# **Cynllun Datblygu Lleol Diwygiedig Sir Gaerfyrddin 2018-2033**

PrC2/SS1 Pentre Awel

Datganiad Tystiolaeth

**PL/03877 - Discharge of Conditions 5 (Written Scheme of Investigation), 27 (Ecological Clerk of Works), 31 (Landscape Environmental Management Plan), 32 (Buffer Zone Scheme), 34 (Landscape Constraints Plan), 36 (Landscape Design Scheme) and 38 (Landscape Maintenance and Management) of S/36948 (Wellness and Life Science Development relating to Phase 1 only of the Outline planning permission S/36948**

Figure 1 xmdf project not opening correctly

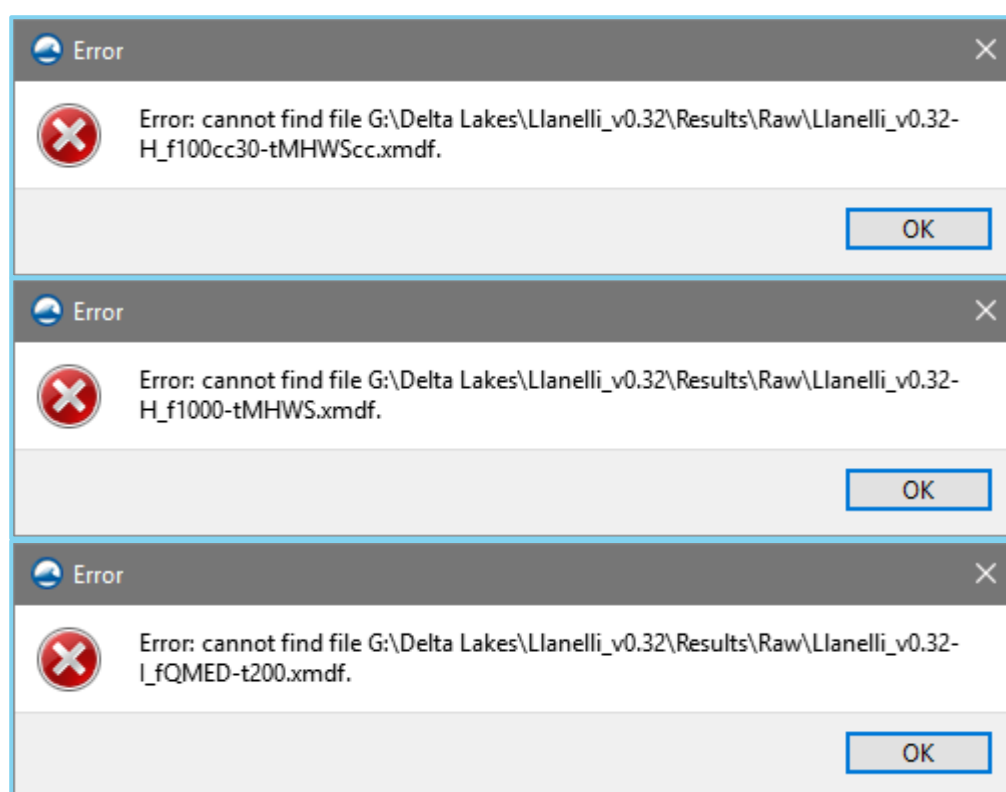
On opening “\*.xmdf.sup” projects in SMS, the project fails to open completely, due to missing data, Figure 1 below, shows some examples of the error messages.

Figure 2 DAT project not opening correctly

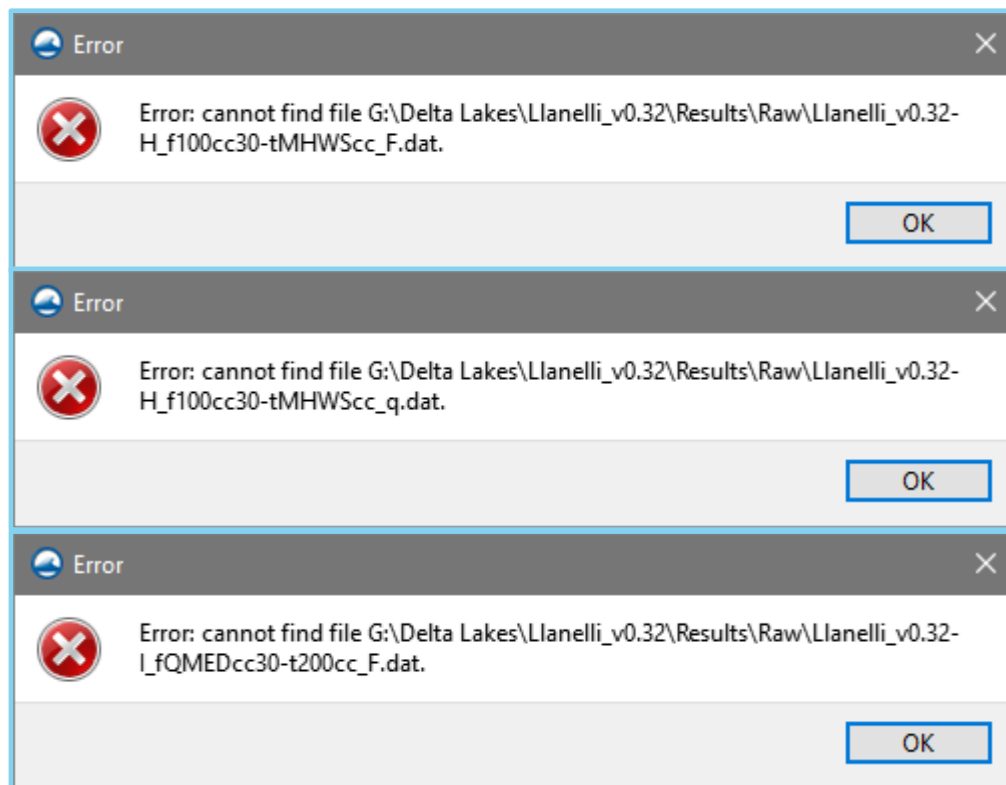
On opening “\*.ALL.sup” project file, the SMS project did not fully open due to missing data, Figure 2 below, shows some examples of the data missing:

Figure 3 Missing GIS results data

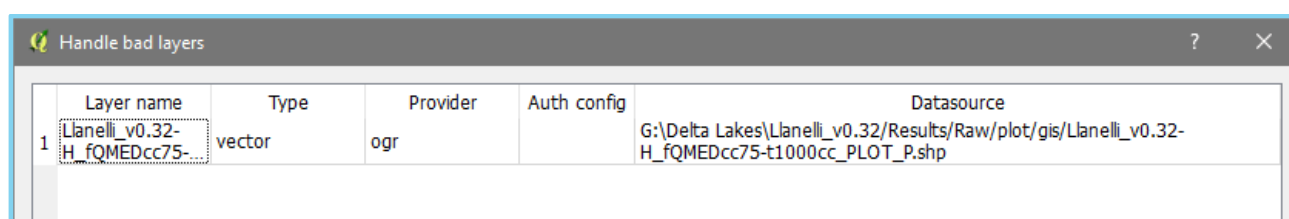
When opening a QGIS project once again this does not fully open due to missing data, this happens as the data under “..\Results\Raw\plot\gis” is not full populated. An example of error reported by QGIS is shown in Figure 3 below.

Figure 5 Sluice gate at Delta Lake outlet

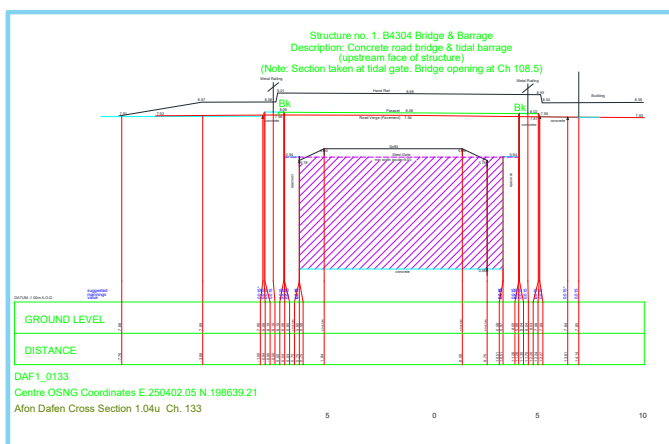
The sluice gates at the outlet of Delta Lakes do not agree with the latest 2018 survey data. The current configuration is likely to allow more tidal floodwater into the lake, than is possible. As there is no sluice gate it is likely for the higher flood risk tidal events that the lake does not store sufficient flood water and hence may underestimate the flood risk. We strongly recommend that the schematisation is reviewed using the latest survey information, see Figure 5.

Figure 6 Latest survey (2018) for structure Dafen\_S5

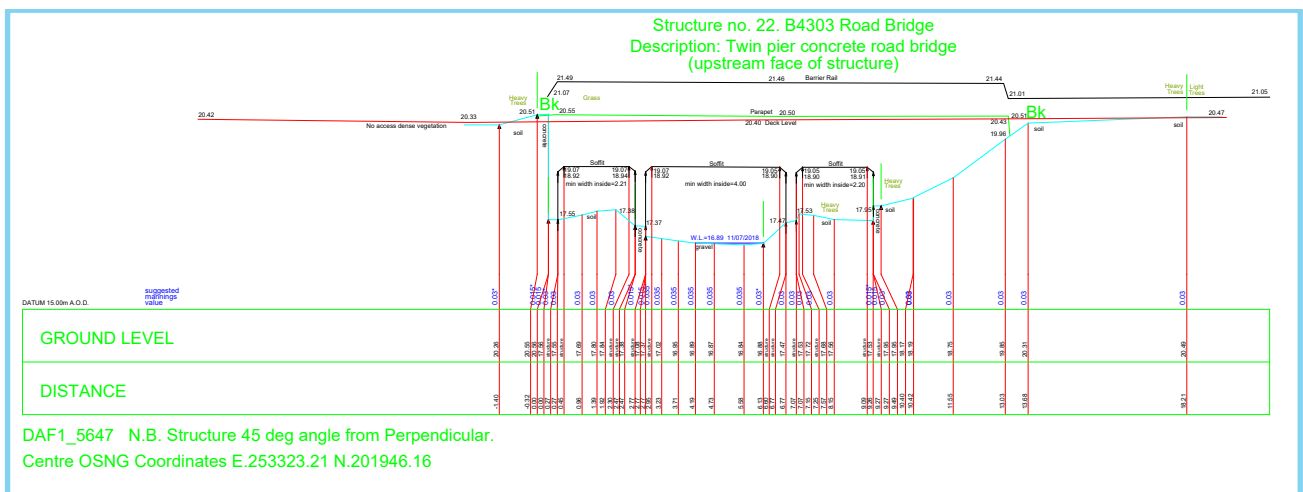
Structure Dafen\_S5 does not agree with the latest survey, Figure 6 gives the detail of the structure.

Figure 8 Llandeilo Junction Culvert Information, based on reviewers understanding from several survey documents, note distance measures form outlet to inlet.

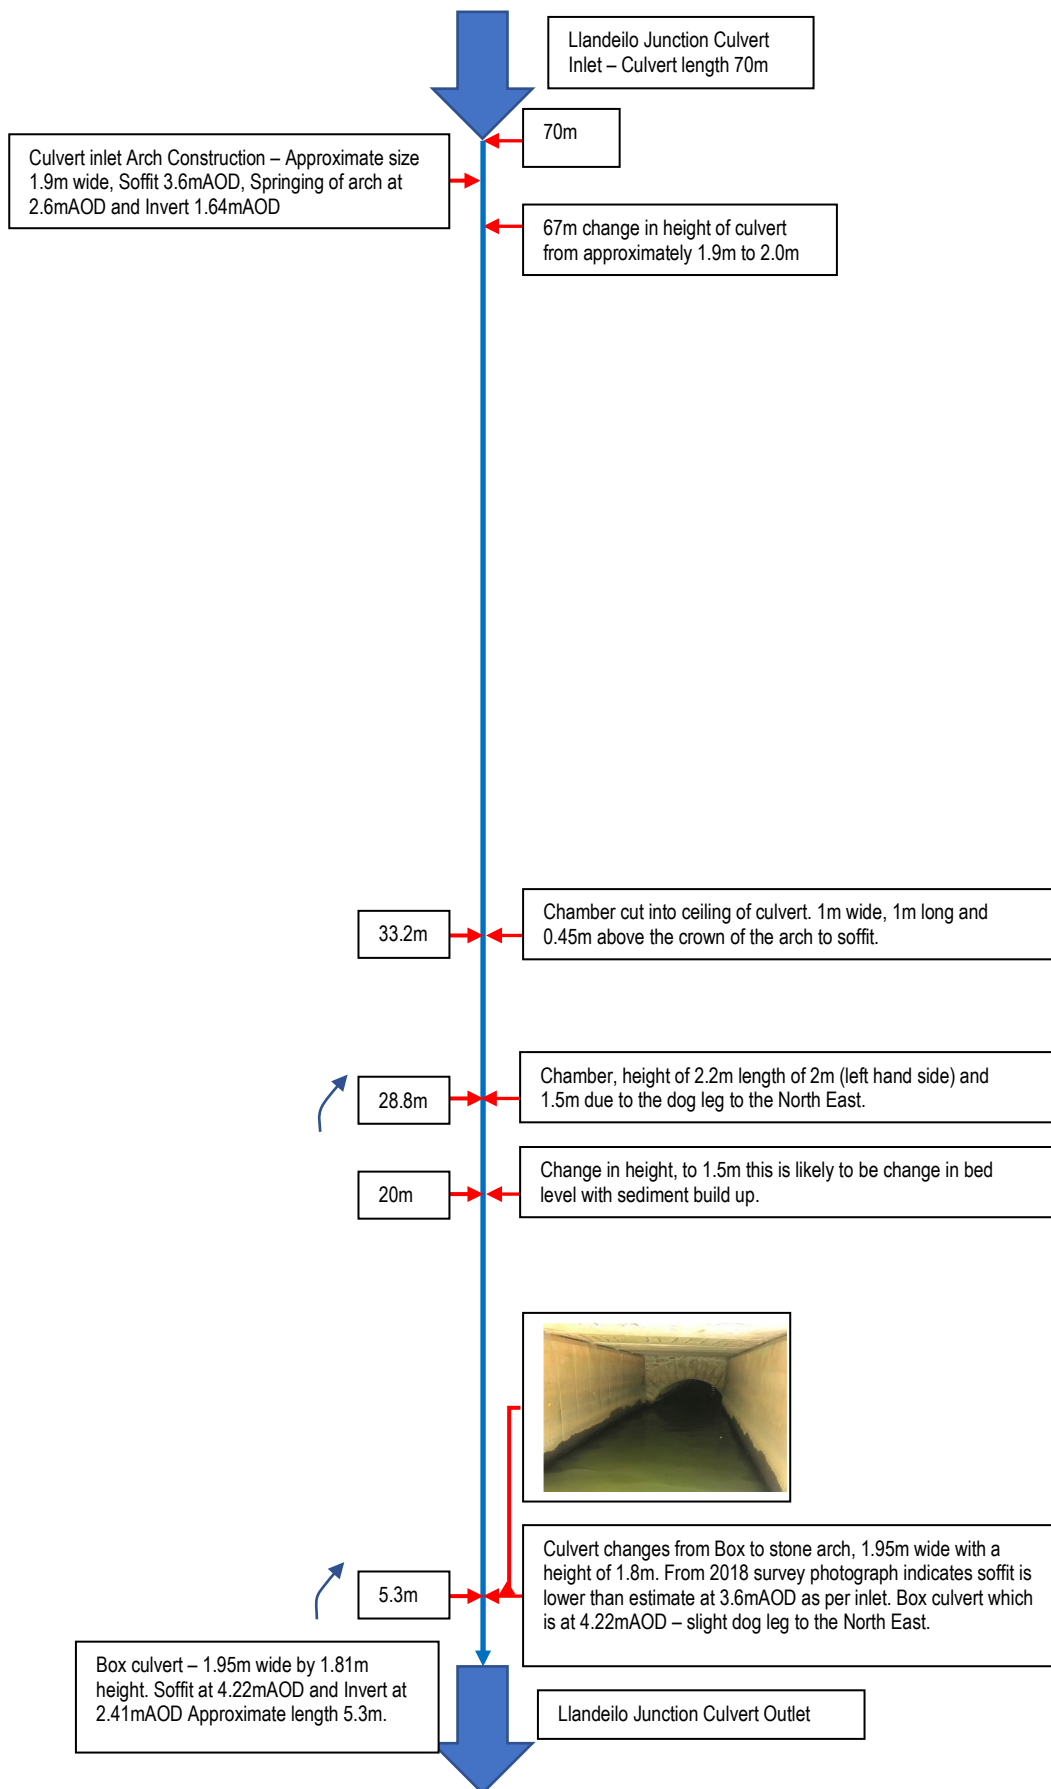
Llandeilo Railway junction culvert details is different to what is present (see Figure 8, this diagram is from all the information available to the reviewer and has been collated into a schematic, to best understand the culvert network under the railway line, with dimensions added to represent the best estimated values). Although the modeller may have simplified the schematisation of the culverts, as there is no MUR to justify the culvert details the reviewer must assume that this is incorrect. Note the schematisation of this culvert network is considered important to the flood risk mechanism at this location, therefore, it is important to understand the assumptions the modeller has made at this location.

Figure 9 HPC model stability

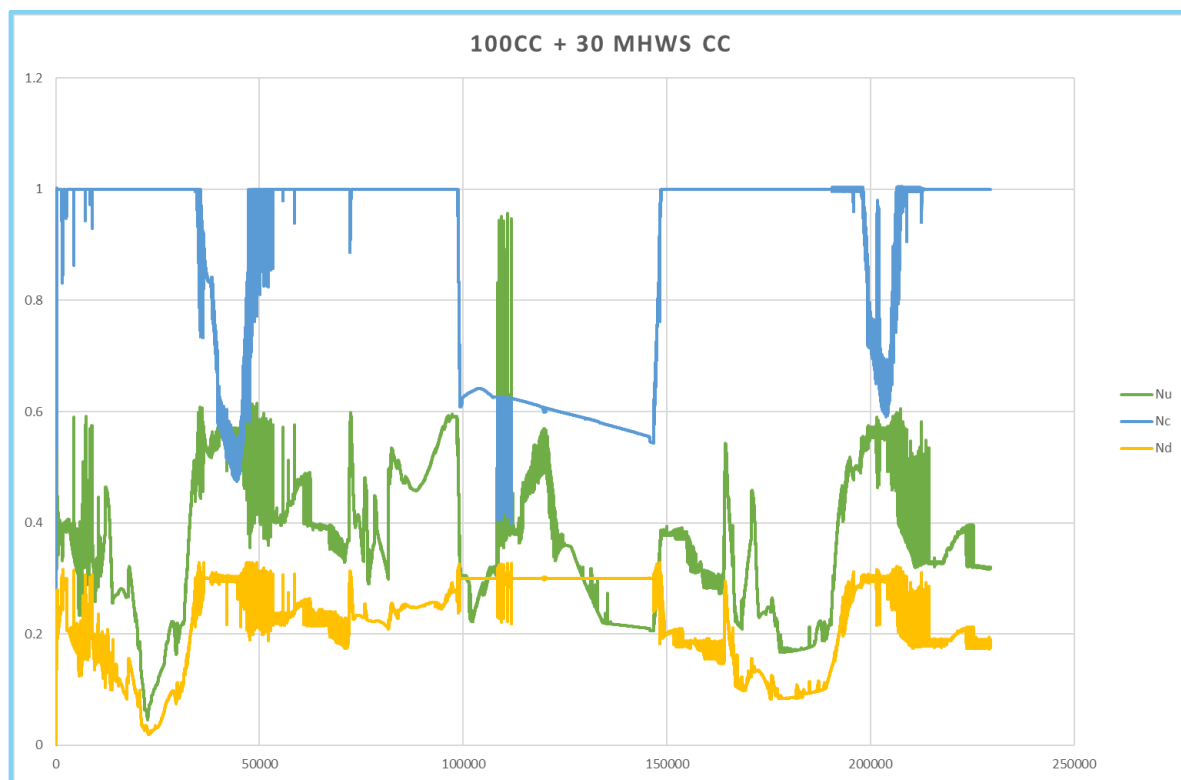
On reviewing “Nu”, “Nd”, and “Nc” values, they all appear to be within the tolerances, although we do note that either “Nd” or “Nc” are at the maximum limit for 100% of time during the simulation runs. We note that “Nd” maximum value recorded is 0.329315 and for “Nc” maximum value of 1.00533, this is outside the recommended values and clarification is needed on this to ensure the model is performing as required.

Figure 10 dt values for 100cc+30% and MHW+cc

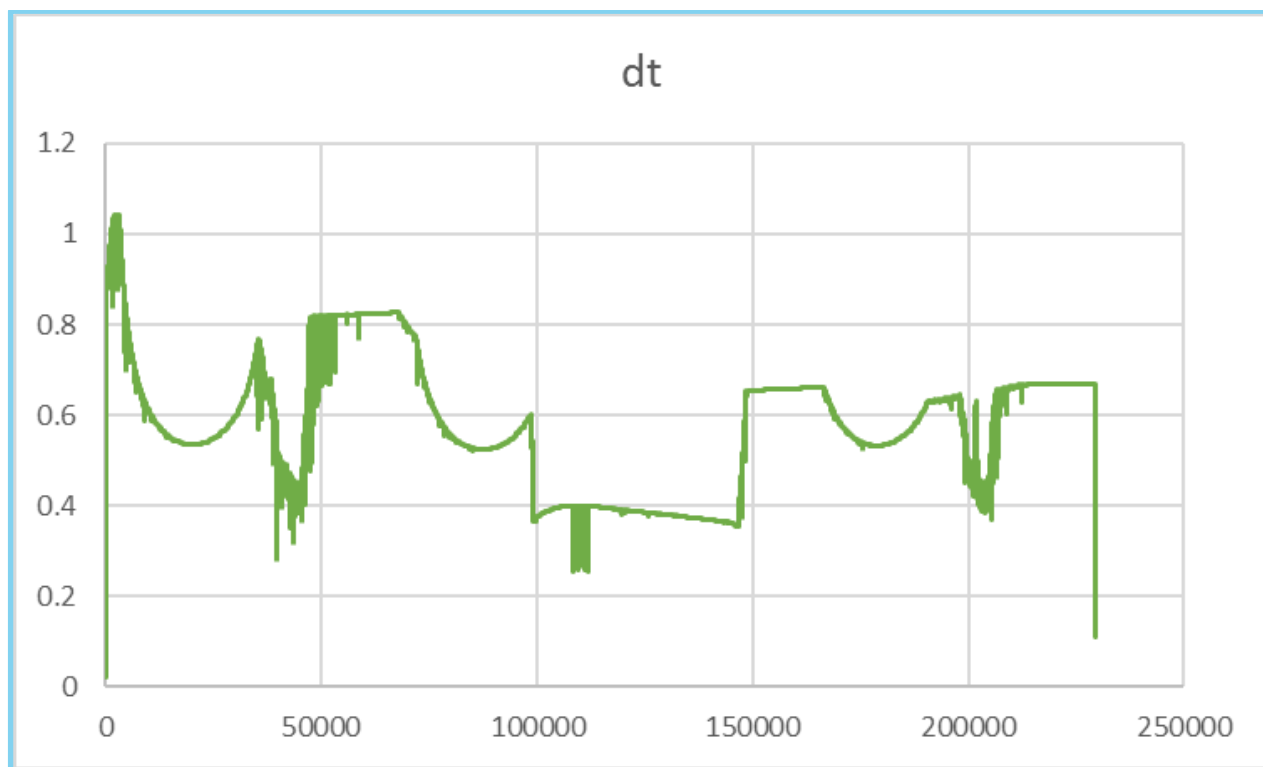
Figure 10 shows how the dt changes over the duration of the simulation, the dt value appears to be within tolerance for the model. Although we can clearly see that the dt value drops in three locations in the chart. These occur at the same time as the Nc value drops. This would indicate that the model is trying to find a suitable value to remain stable. Clarification is required that this is not impacting the model's performance and not impacting the results.

| Review Section | Response – EVY and NRW                                                                                                                                                                                                                                                                                                                                                                                                                                                                                                                                                                                                                                                                                                                                                                                                                                                                                                                                                                                                                                                                                                                                                                                                                                                                                                                                                                                                                                                                                                                                                                                                                                                          | Subject Area                 | Assessment of impact of adopting NRW suggestions                                                                                                                                                                         |
|----------------|---------------------------------------------------------------------------------------------------------------------------------------------------------------------------------------------------------------------------------------------------------------------------------------------------------------------------------------------------------------------------------------------------------------------------------------------------------------------------------------------------------------------------------------------------------------------------------------------------------------------------------------------------------------------------------------------------------------------------------------------------------------------------------------------------------------------------------------------------------------------------------------------------------------------------------------------------------------------------------------------------------------------------------------------------------------------------------------------------------------------------------------------------------------------------------------------------------------------------------------------------------------------------------------------------------------------------------------------------------------------------------------------------------------------------------------------------------------------------------------------------------------------------------------------------------------------------------------------------------------------------------------------------------------------------------|------------------------------|--------------------------------------------------------------------------------------------------------------------------------------------------------------------------------------------------------------------------|
| 38.            | <p>Section 2.6- 4th Paragraph</p> <p>Edenvale Young is not aware of guidance associated with this statement "the dt value appears to be within tolerance for the model"?</p> <p><i>Noted – NRW comment relates that the model was performing well when looking at “dt” value and that it wasn’t running at the lowest possible value which would indicate the model was at its limits of stability. The modeller may wish to note the following from TUFLOW release notes 2017 –</i></p> <p><i>The minimum permissible target timestep allowed by the HPC solver is set using the .tcf command below. By default this is set to the minimum of 0.1s or the cell size divided by 200 m/s. In most cases, where there is no erroneous data or poor model setup, the target timestep will always be well above the default minimum timestep.</i></p>                                                                                                                                                                                                                                                                                                                                                                                                                                                                                                                                                                                                                                                                                                                                                                                                                               | Model stability              | <p>NRW statement is incorrect<br/><i>NRW statement is correct</i></p>                                                                                                                                                    |

Figure 12 Shows tide flowing into the lake during the peak of the tide cycle

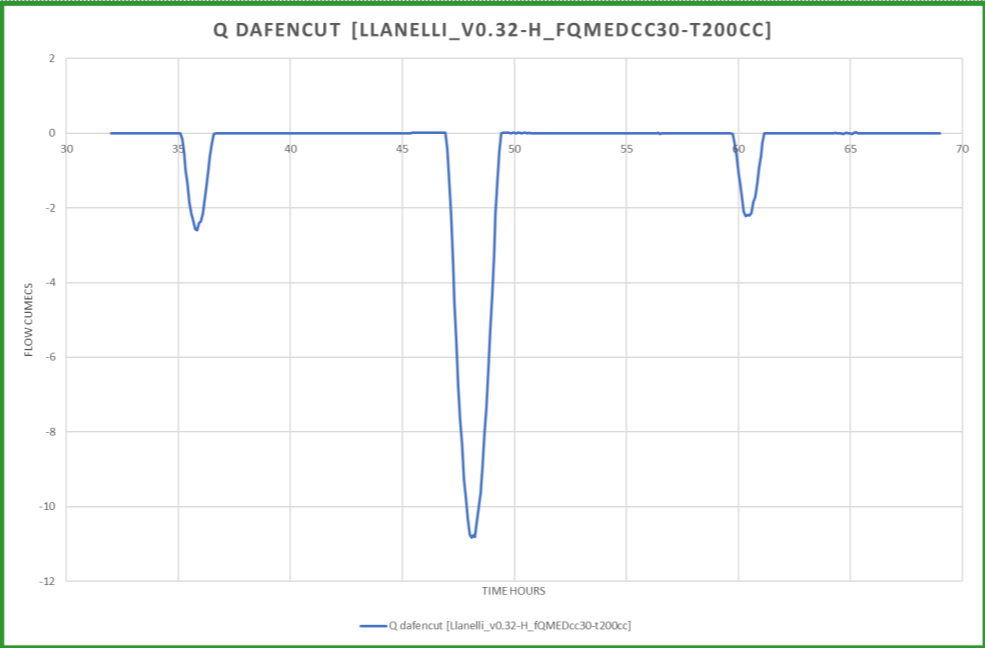
| Review Section | Response – EVY and NRW                                                                                                                                                                                                                                                                                                                                                                                                                                                                                                                                                             | Subject Area | Assessment of impact of adopting NRW suggestions |
|----------------|------------------------------------------------------------------------------------------------------------------------------------------------------------------------------------------------------------------------------------------------------------------------------------------------------------------------------------------------------------------------------------------------------------------------------------------------------------------------------------------------------------------------------------------------------------------------------------|--------------|--------------------------------------------------|
|                | <p>The model clearly shows that the sluice gate overtops and the tide flows into the lake. NRW are unable to comment whether the lake will fill and then spill out over the sluice gate due to the lake being dry at start of simulation see Figure 12.</p> <p>The inlet culvert to Delta Lakes is unstable in the later stages of the simulation this will need to be corrected, see Figure 13 and Figure 14.</p> <p>These points above must be corrected.</p> <div><p>Q DAFENCUTC [LLANELLI_V0.32-H_FQMEDCC30-T200CC]</p><p>Figure 11 Delta Lakes outlet culverts flow</p></div> |              |                                                  |
